Access Compliance Report

Public Rights-of-Way

(Curb Ramps)

Intersection ID: 30502	Main Street: ORCHARD_GRASS_CT	Cross Street: STONES_LANDING_ST	Location: NW
ADA ID: 3FFF9FB5F5CE	Ramp Type: PerpDiag	Initial Pass/Fail: Fail	Overall Compliance: No
Severity Score: 22.5			
Codes/Mitigation Info/Possible Solution		Field Measurements/Component Compliance

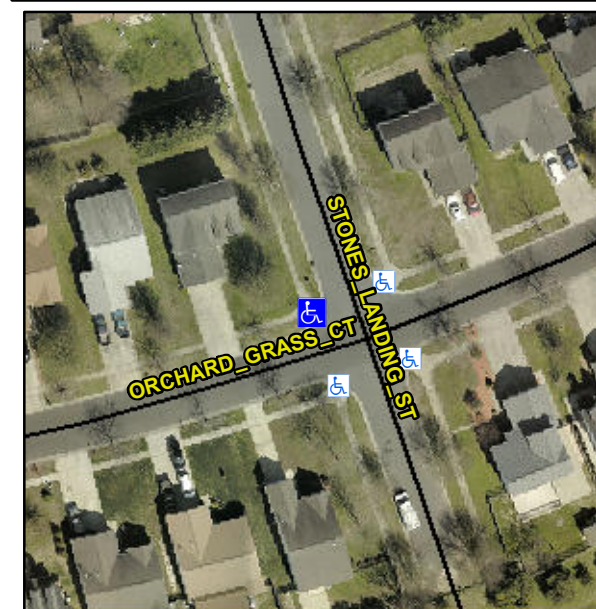
R304.5.1, R304.2.2, R304.5.3

Compliance	Description	Data	Compliance	Description	Data
N/A	Ramp Length (in)	118.0	No	Ramp Slope (%)	8.6
No	Ramp Width (in)	45.5	No	Ramp XSlope (%)	3.9
N/A	Flare Type LT	N/A	N/A	Flare Type RT	N/A
N/A	Flare Slope LT (%)	N/A	N/A	Flare Slope RT (%)	N/A
N/A	Flare Traversable LT?	N/A	N/A	Flare Traversable RT?	N/A
N/A	Landing Length (in)	N/A	N/A	DWS Provided?	N/A
N/A	Landing Width (in)	N/A	N/A	DWS Contrast?	N/A
N/A	Landing Slope (%)	N/A	N/A	DWS Length (in)	N/A
N/A	Landing X Slope (%)	N/A	N/A	DWS Full Width?	N/A
N/A	Landing Curb? (Y/N)	N/A	N/A	DWS Offset (in)	N/A
N/A	Shared Landing?	N/A			
N/A	Gutter Ponding?	N/A	N/A	Gutter Slope (%)	N/A
N/A	Gutter Lip Ht (in)	N/A	N/A	Gutter X Slope (%)	N/A
N/A	Painted X Walk1?	No	N/A	Painted X Walk2?	No
	X Walk 1 Direction	To S		X Walk 2 Direction	To E
N/A	X Walk 1 Width (in)	N/A	N/A	X Walk 2 Width (in)	N/A
	X Walk 1 Slope (%)	3.6		X Walk 2 Slope (%)	1.4
	X Walk 1 X Slope (%)	1.9		X Walk 2 X Slope (%)	0.9

Remove & Replace Curb Ramp With Two New Directional Ramps or Equivalent.
